APPLICANT: Westinghouse Electric Corporation
PROJECT: AP600
SUBJECT: SUMMARY OF AP600 MEETING ON PROPOSED DESIGN CHANGES RELATED TO POST-72 HOUR ACTIONS

WESTINGHOUSE - NRC MEETING
ON PROPOSED AP600 DESIGN CHANGES TO ADDRESS
POST-72 HOUR ACTIONS
FEBRUARY 4, 1997

AP600 Systems Changes Post 72 Hour and Spent Fuel Pool Cooling

PCS / SFS MAKEUP : CHANGES

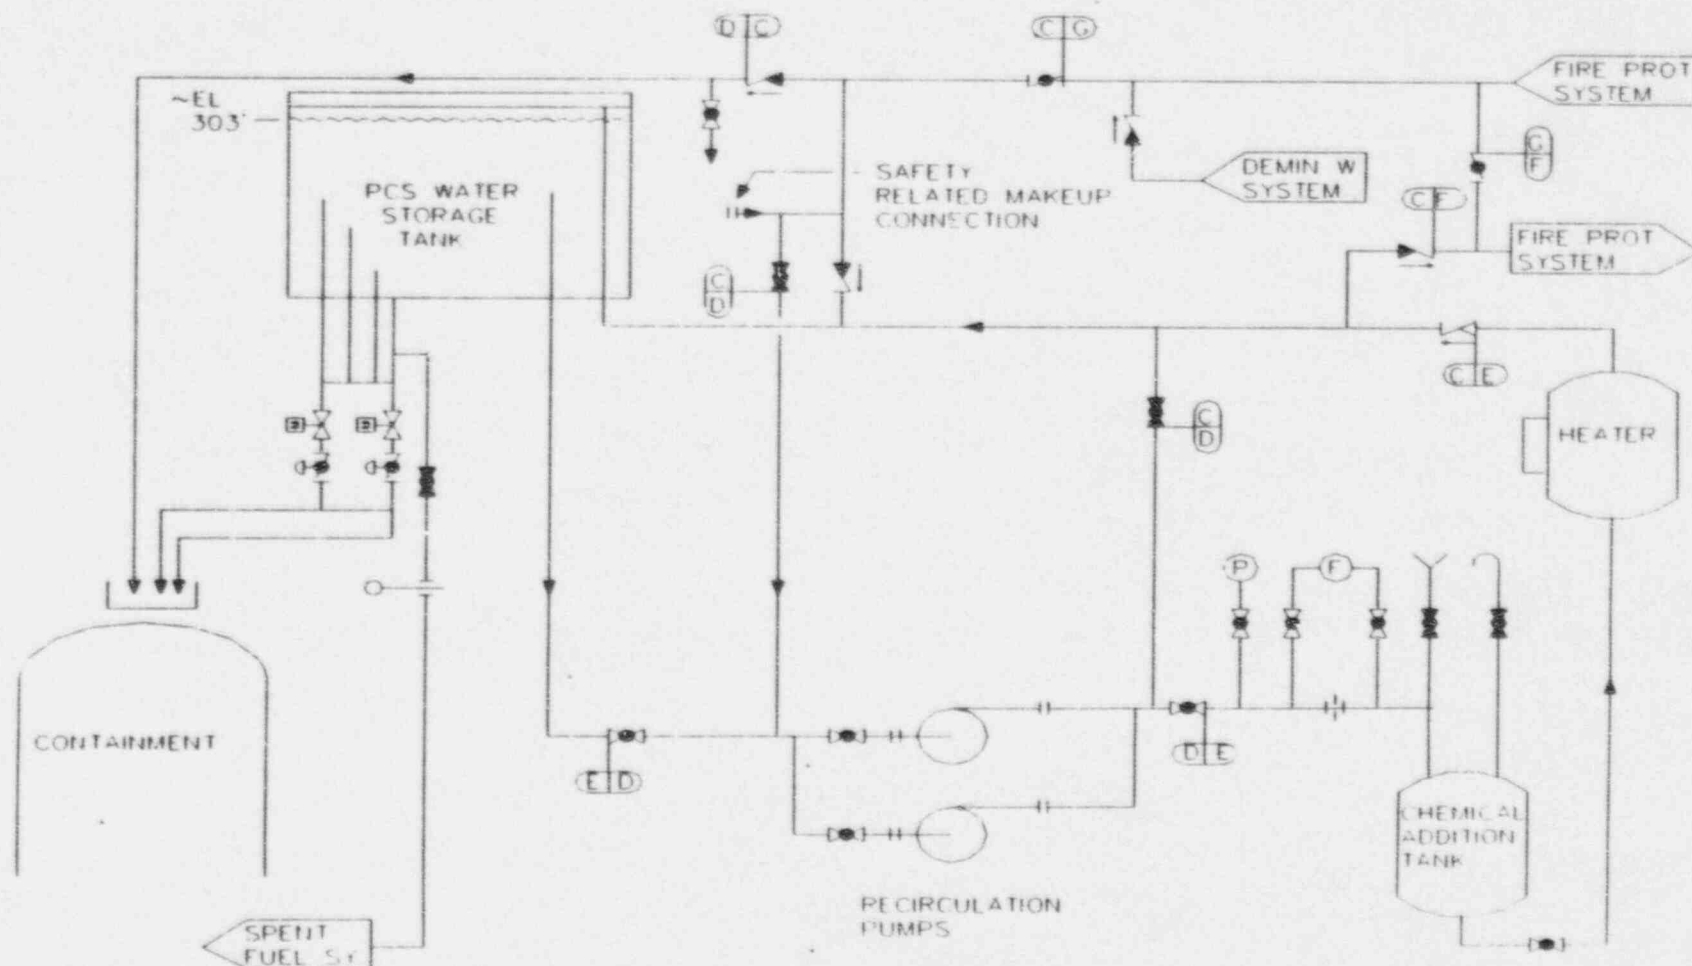
- Additional 150,000 gallons of water in PCS storage tank on top of shield building
- Add fourth stage standpipe for additional control of flow from PCS tank to containment shell over 7 days
- Modify PCS recirculation path to also serve as post 7 day onsite equipment for makeup to PCS tank
 - Replace single pump with two higher head pumps
 - Modify piping/valves to provide pump suction from grade level connection to water tankers
 - Backup power to pumps from ancillary diesels
- Add piping connection from PCS tank to spent fuel pool for long term makeup in scenarios with no fuel in reactor vessel

AP600 PCS/SFS Makeup Changes

AP600 SPENT FUEL POOL COOLING SYSTEM
AFTER CHANGES

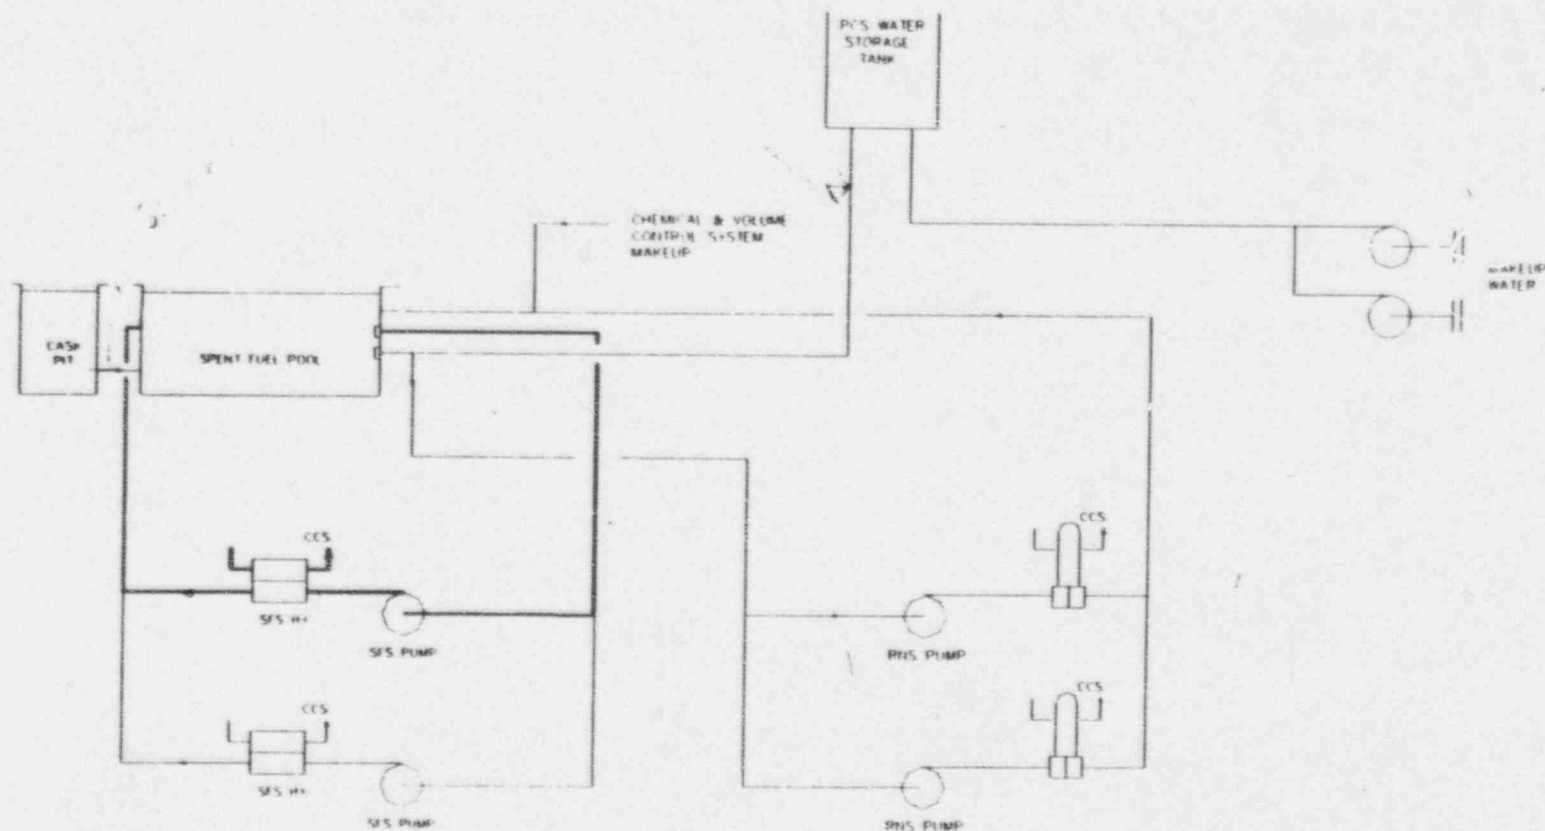
- **AP600 SFS Design Changes (continued)**
 - Cross connections added to normal residual heat removal system (RNS)
 - RNS can provide 100% of SFP cooling when normal RHR is not in use for RCS
 - RNS pressure boundary is Seismic I
 - Seismic I makeup water line added from safety-related PCS water storage tank
 - Seismic I makeup water line added from cask wash down pit (CWP)

Figure 1.2.19

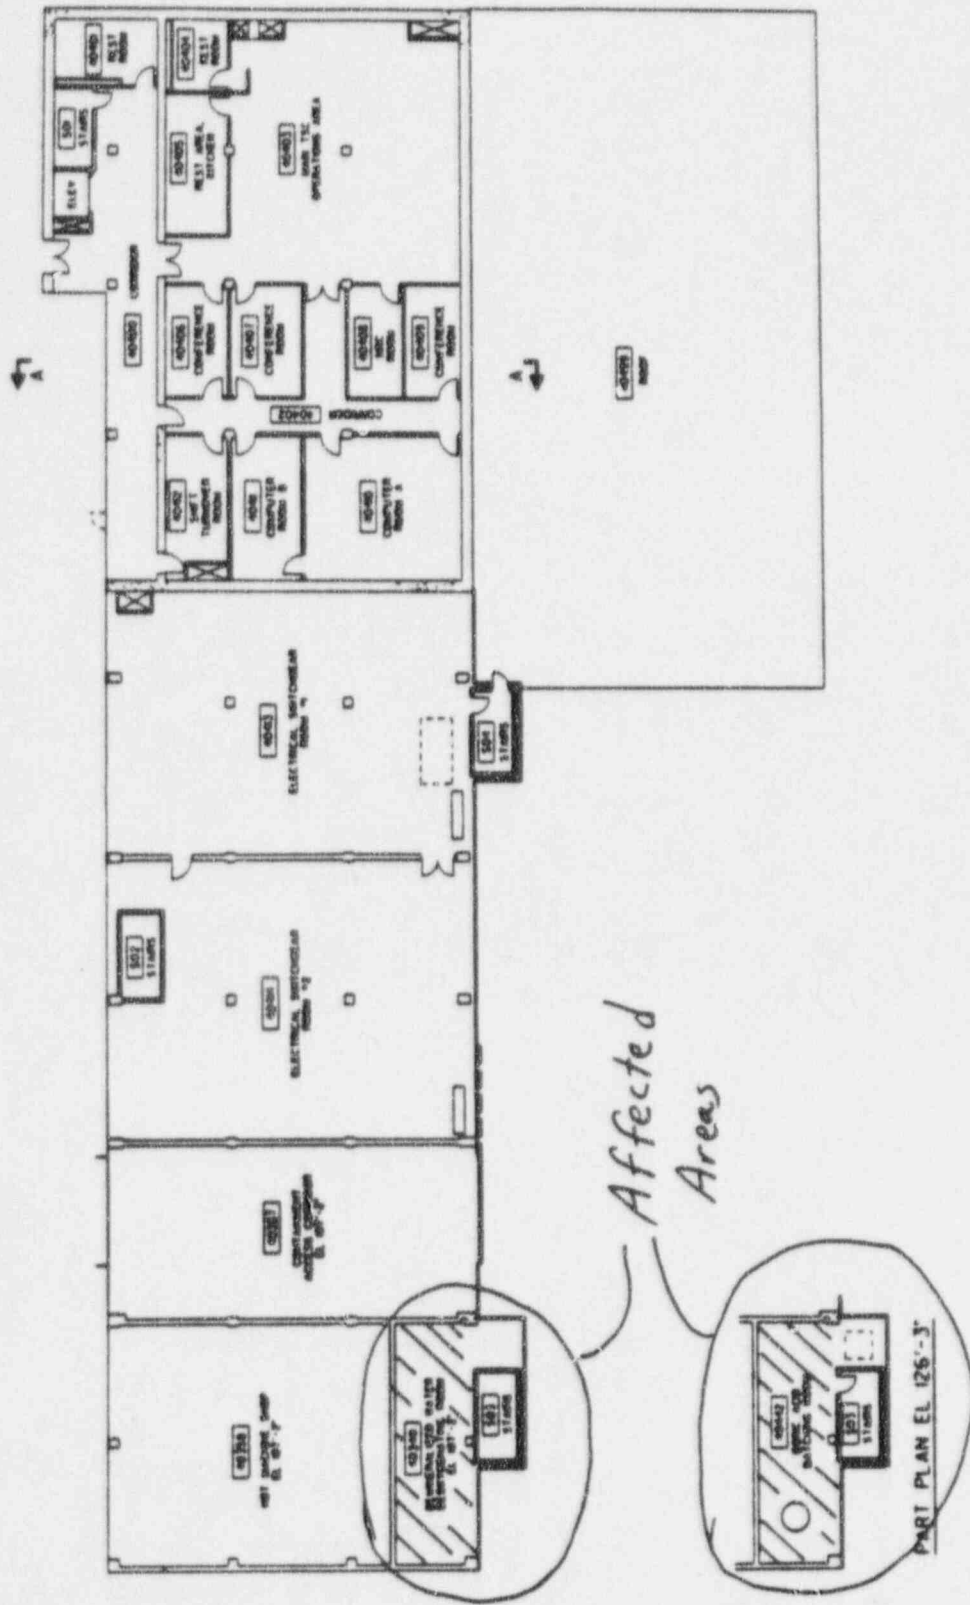
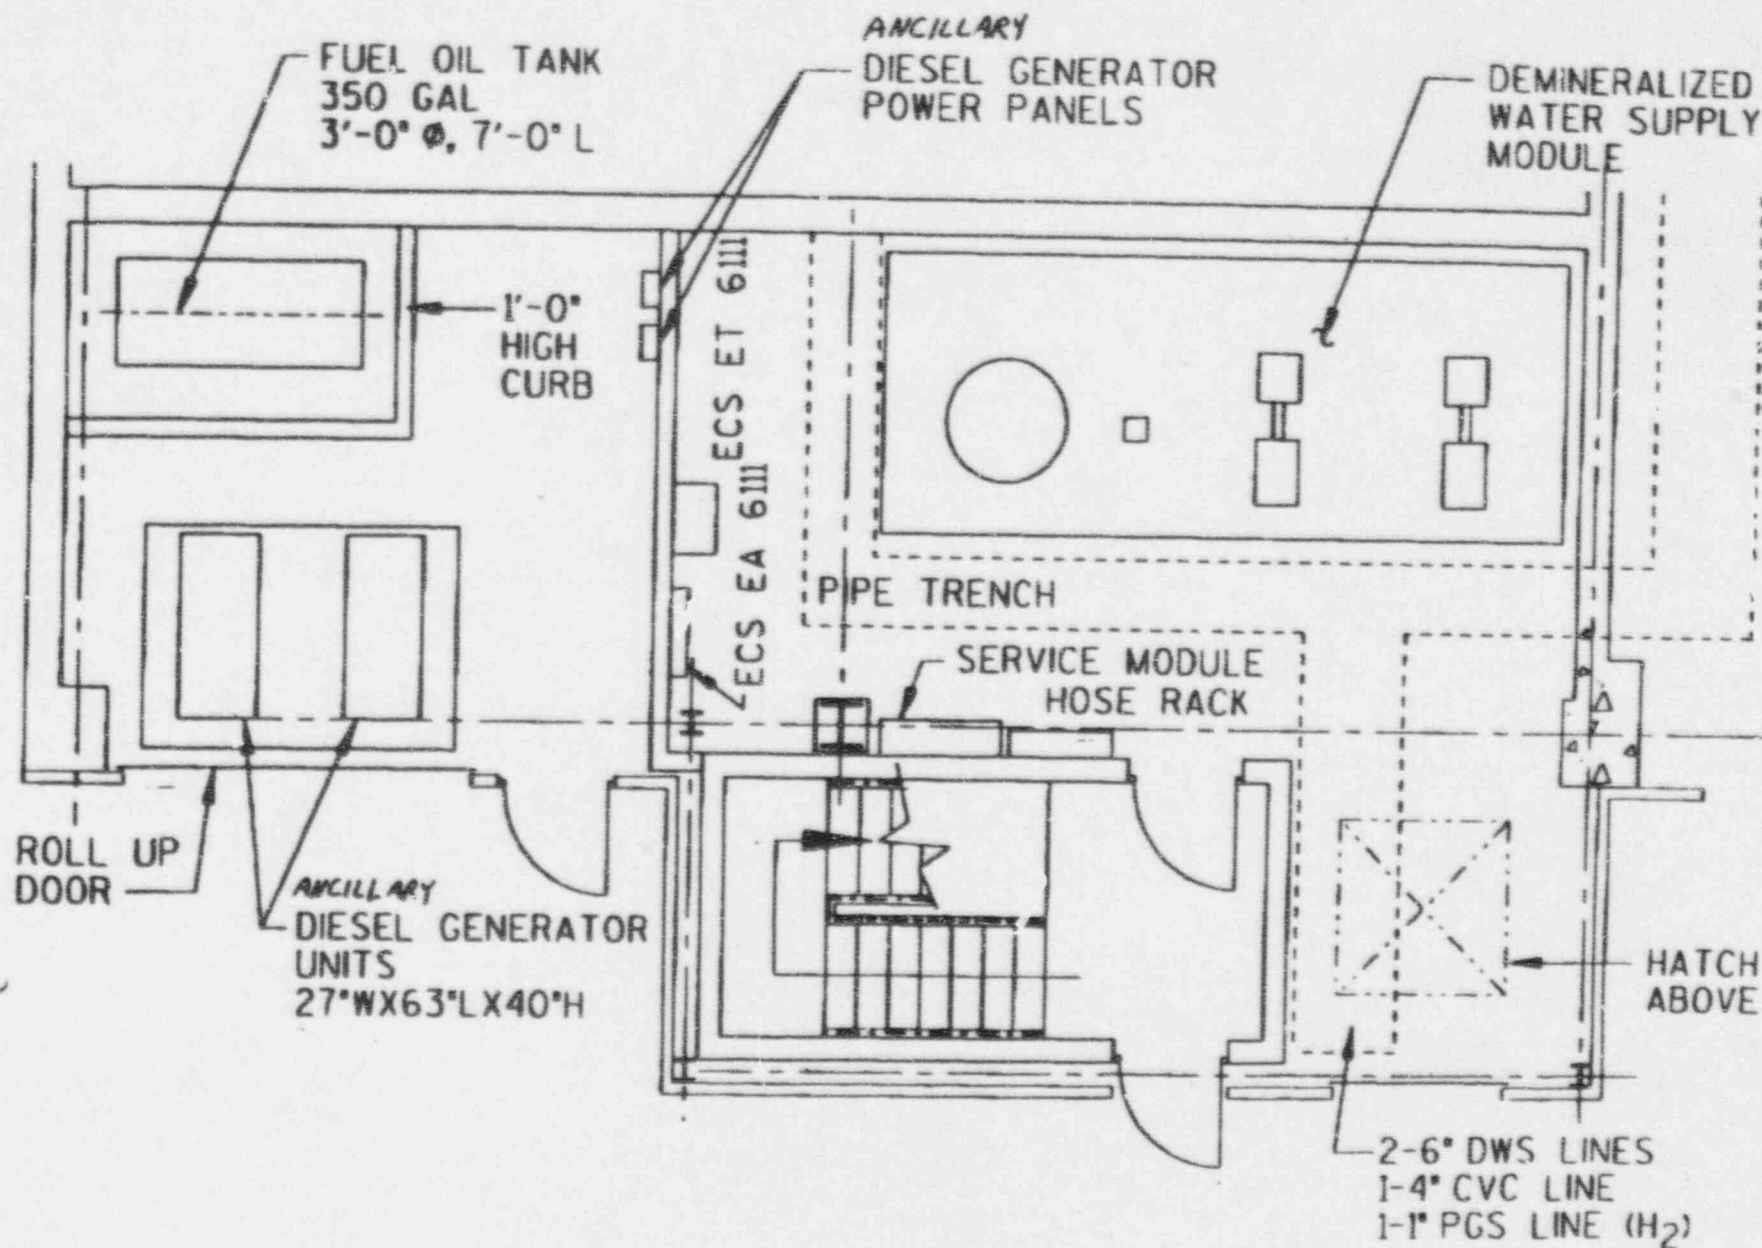
- Two independent 15 kW units and fuel source located together in annex building.
- Located in south-east corner of annex building.
 - *New room with large outside door*
 - *Protected from SSE and 145 mph winds*
 - *Located above site maximum flood level*
- Packaged unit (skid-mount)
- Equipment Class D
 - Rugged design, will withstand SSE
 - Seismic anchors

Figure 8.3.2.2

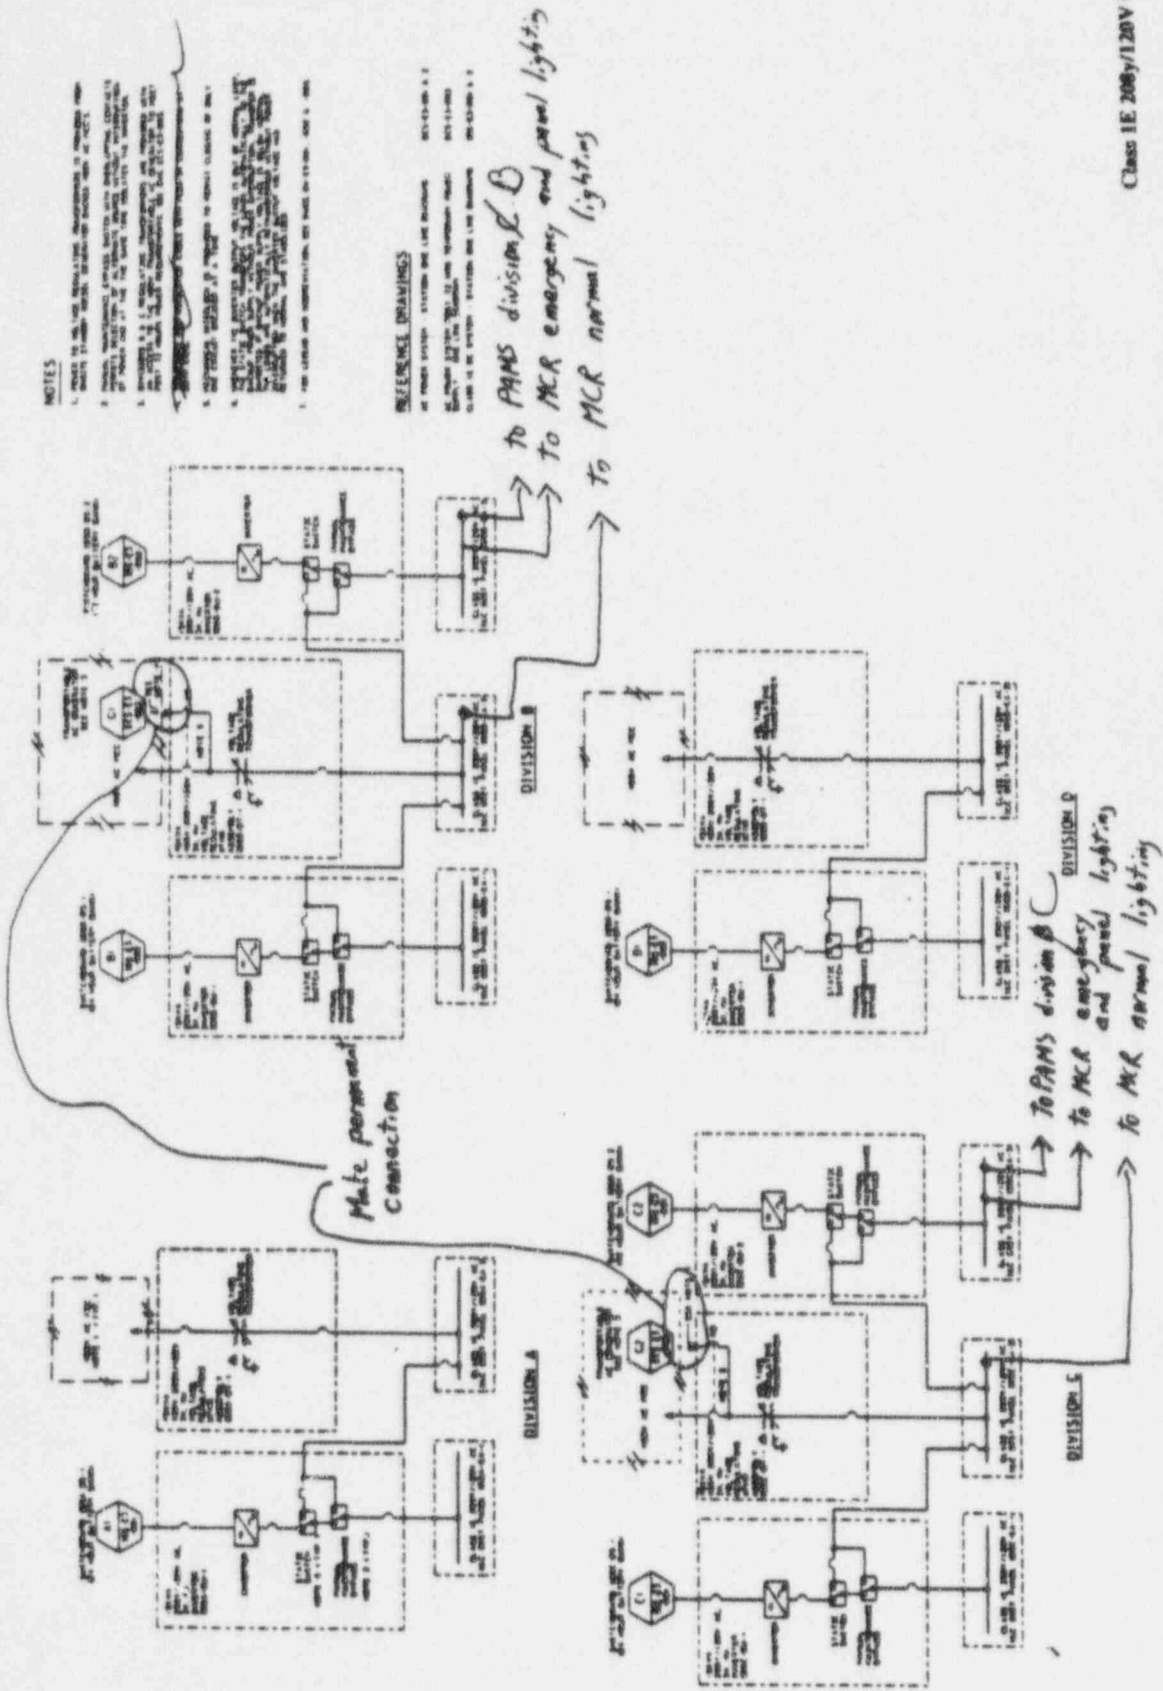
Revise figures 8.3.1-3 & 8.3.2-2 to show ancillary diesel generator configuration.
